Technical bulletin N°3

Reference : BT_2008_FR20_03

Subject : Lift points on the central wooden floor

Central wooden floor

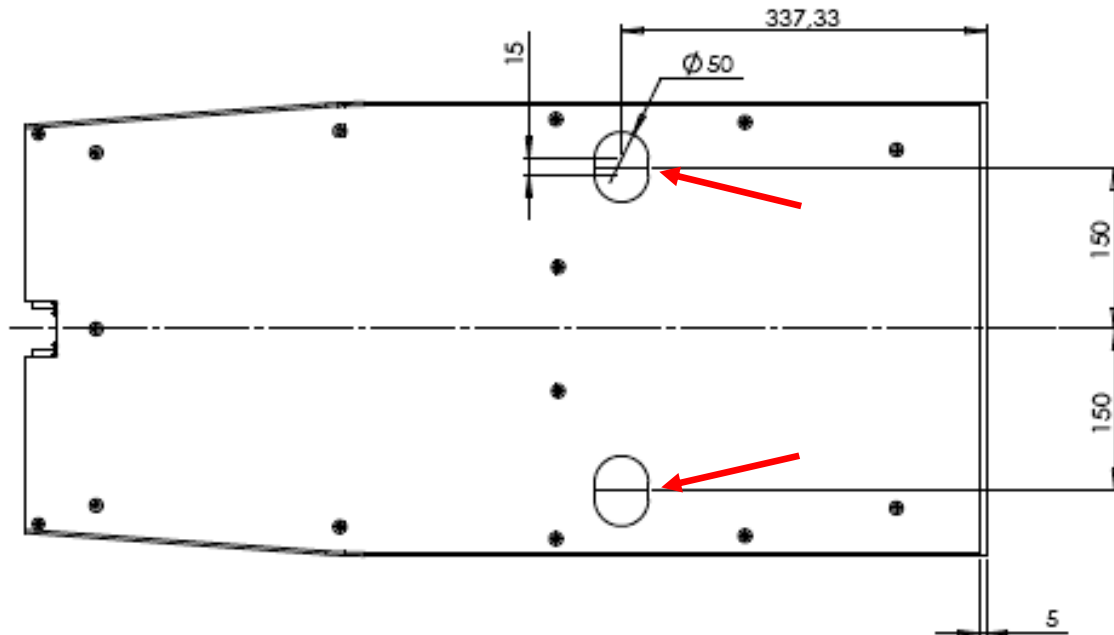
For Formula Renault 2.0 Eurocup 2008, the central wooden floor (ref 77 11 163 104) must be drilled in order to enable the Renault Sport scrutineers to check all the cars on the Renault Sport control plane. Two holes must be drilled according to the drawing below:
